ADDENDUM NO. 3

COMMUNITY PARK ELEMENTARY SCHOOL

Issued: January 30, 2026

FVHD PROJECT NO. 5516C

A002

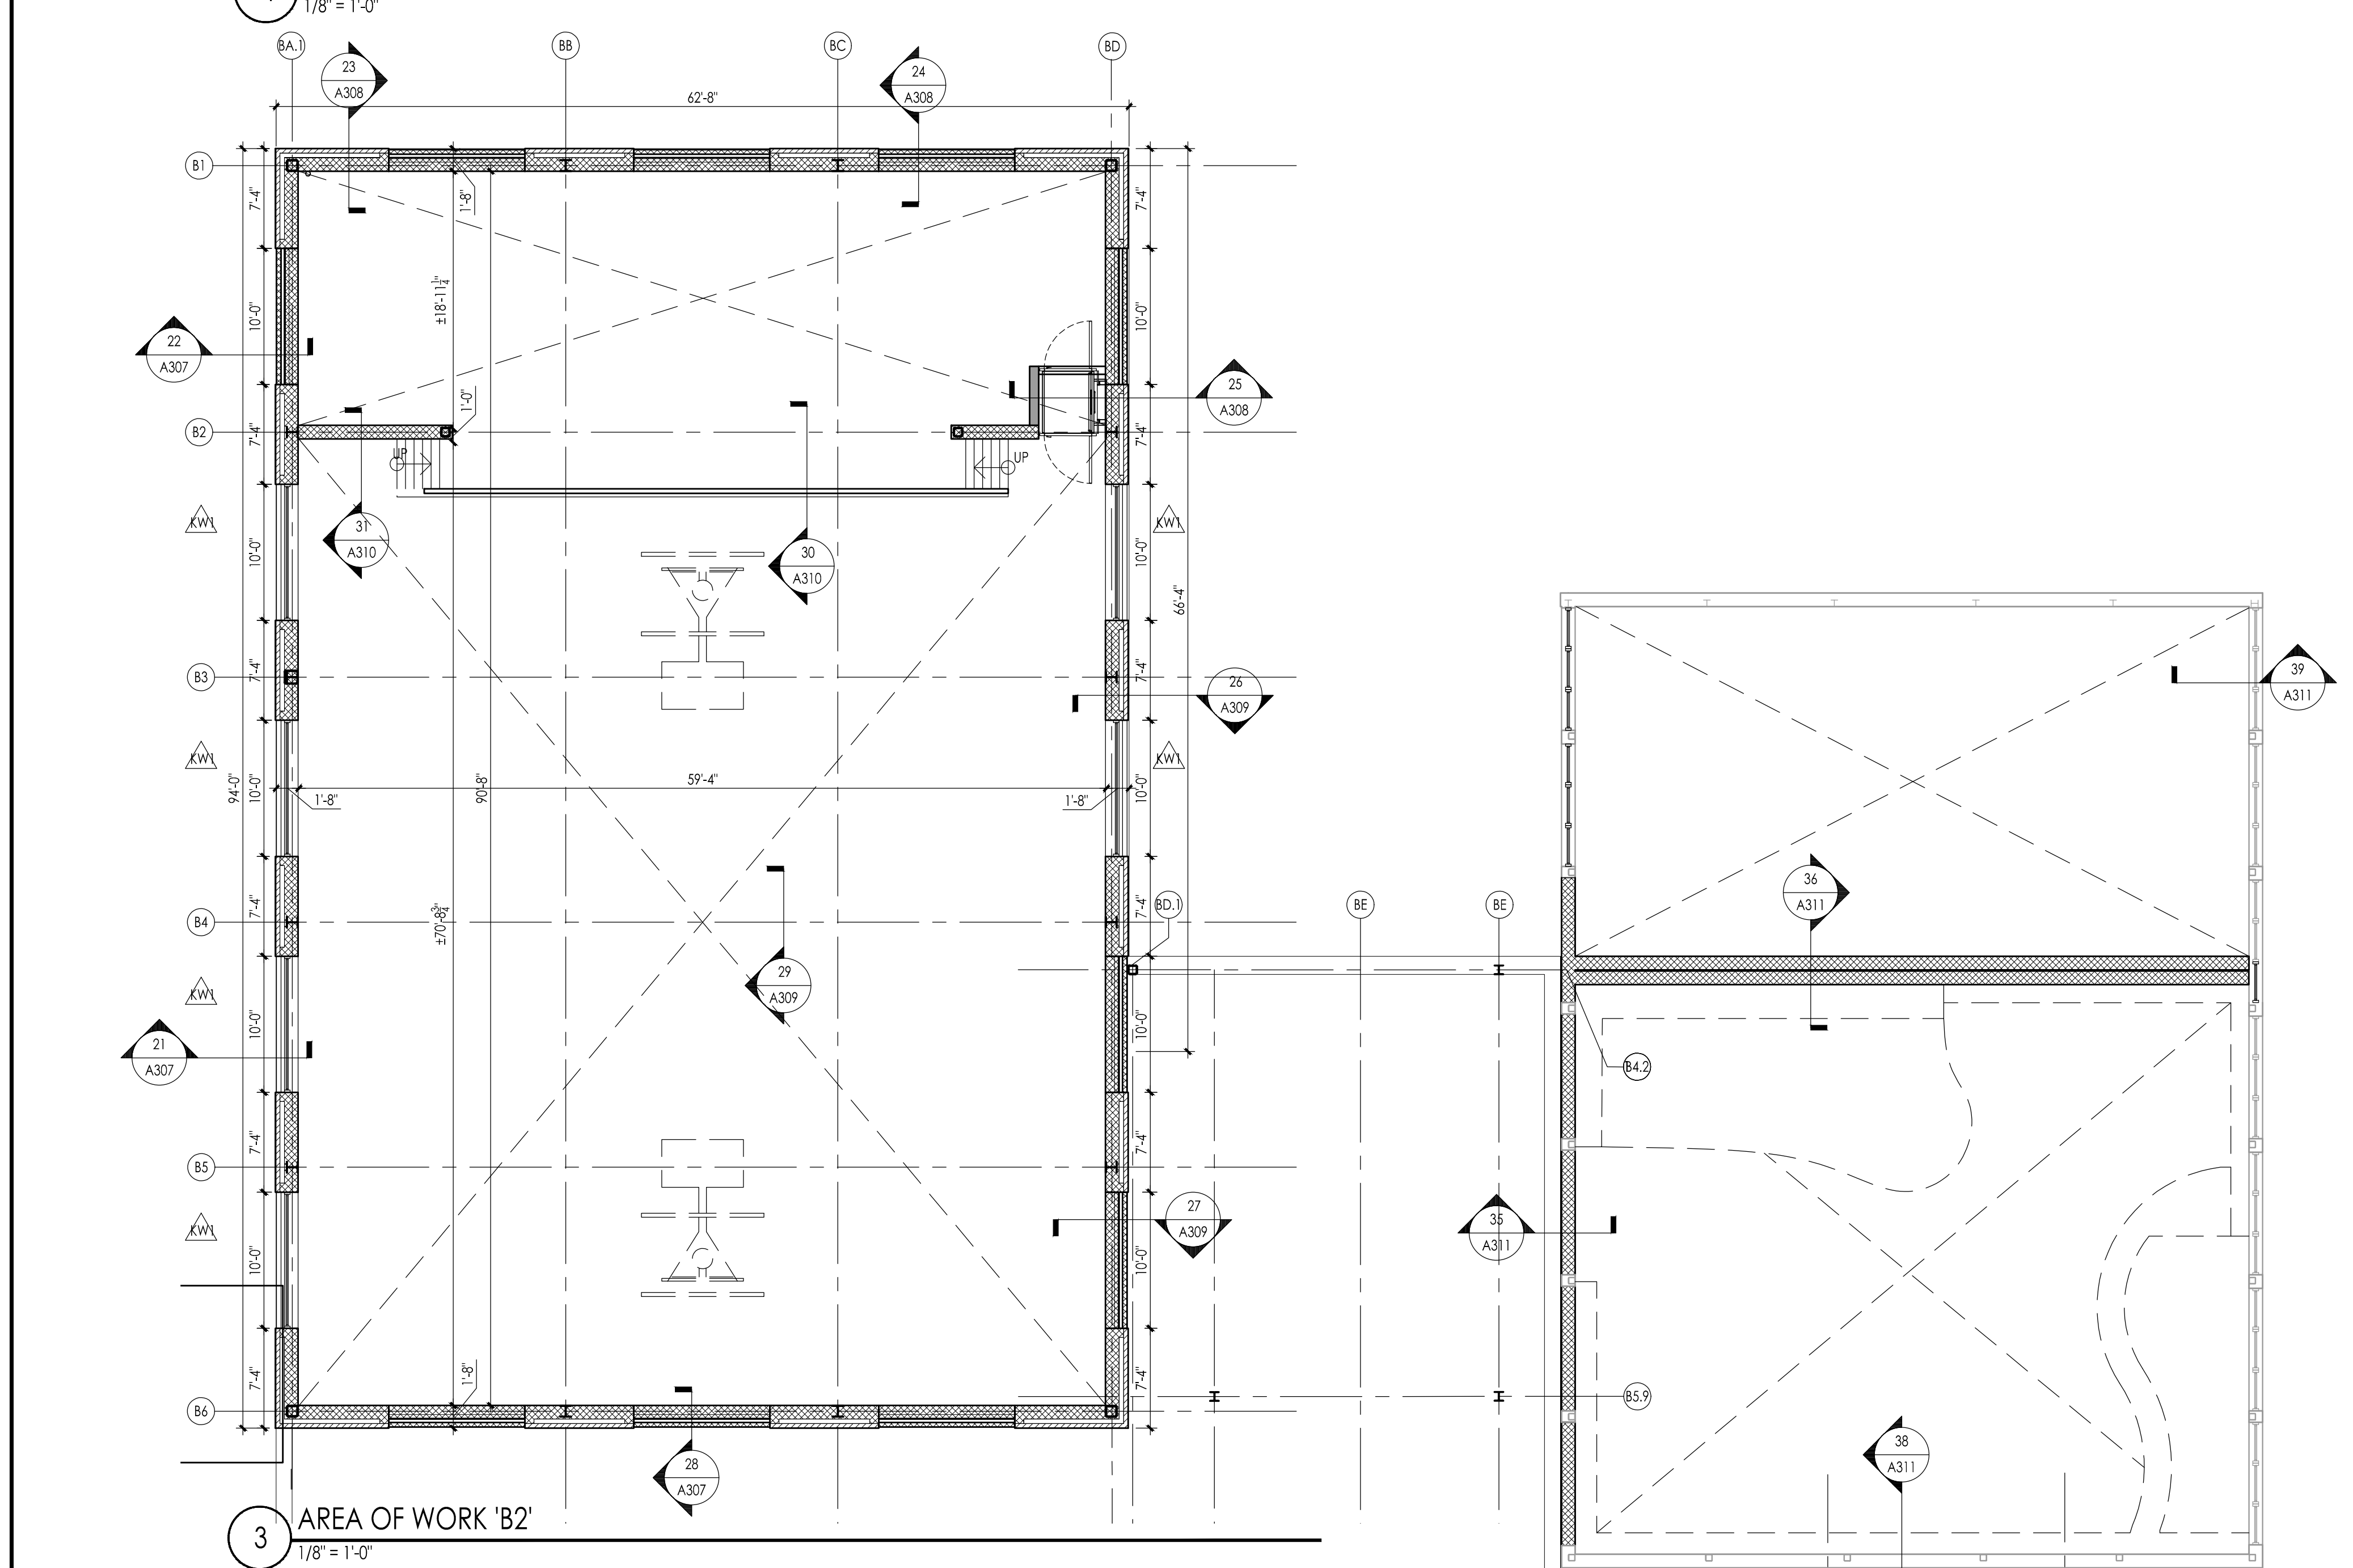
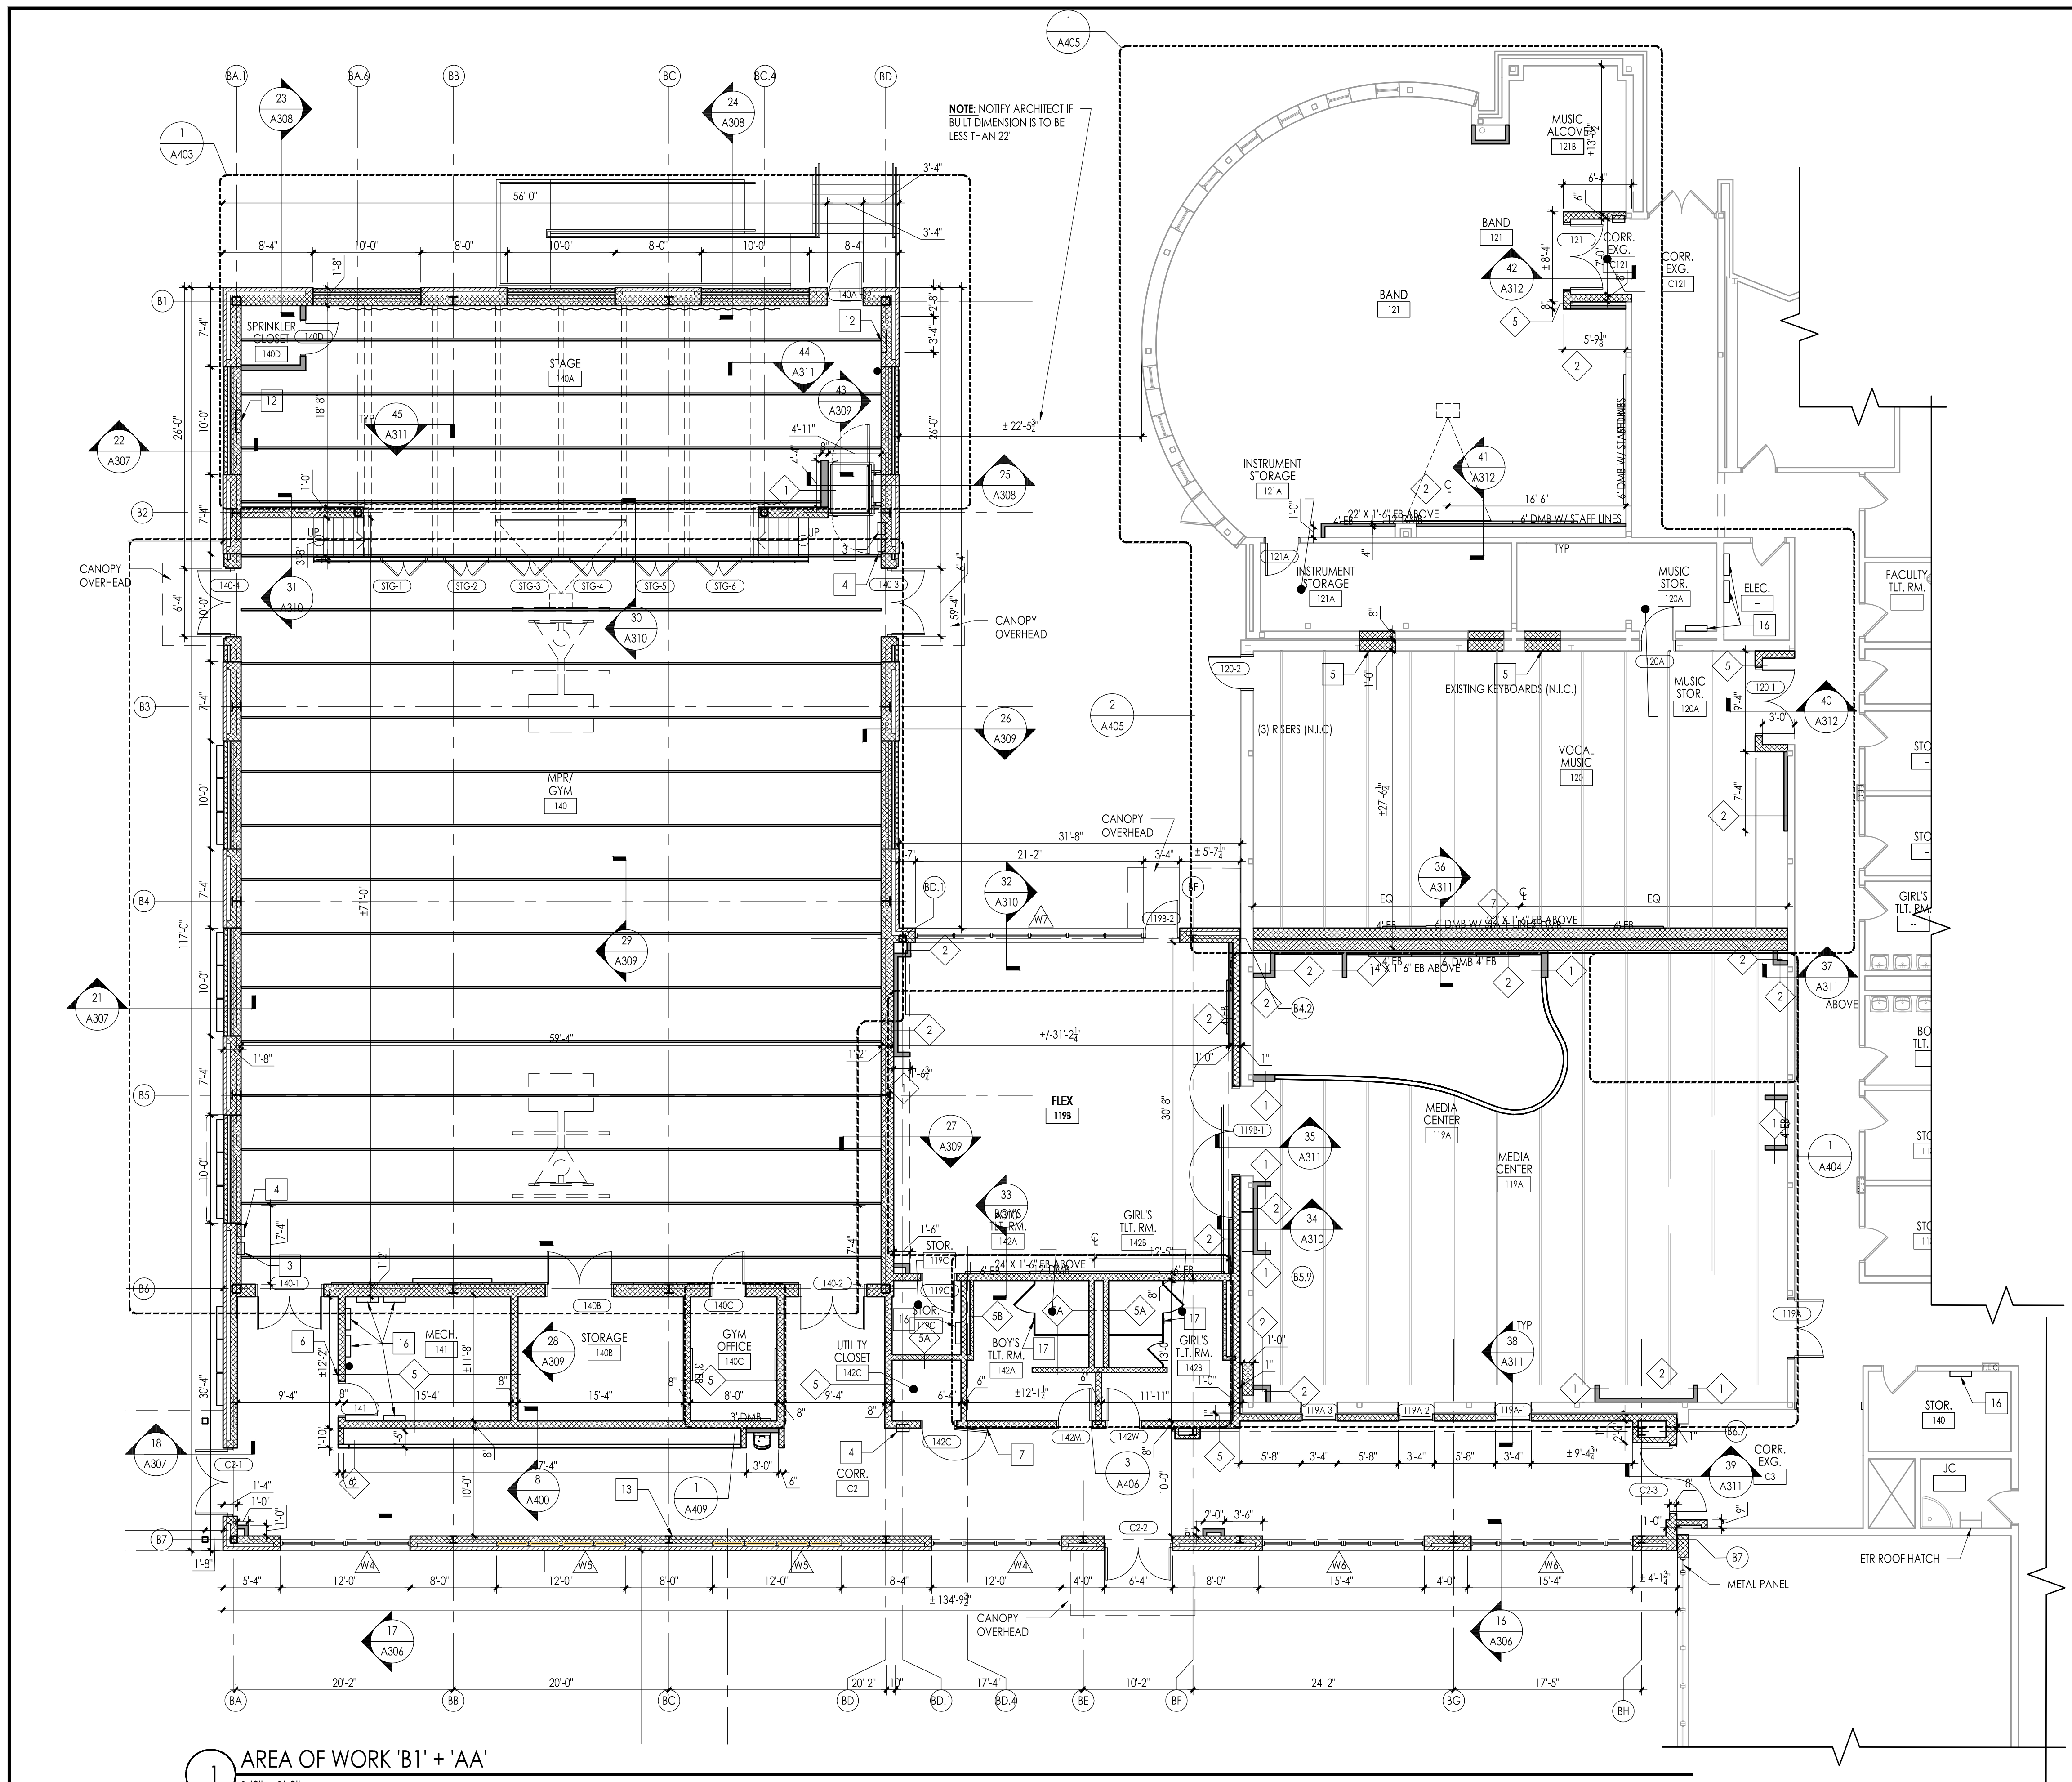
1. Question: Spec Section 08340 for Overhead Coiling Grille Door but nothing on drawing. Confirm this section is not needed

Response: See revised A104, A407 and A601 for location and details related to the Overhead coiling grille.
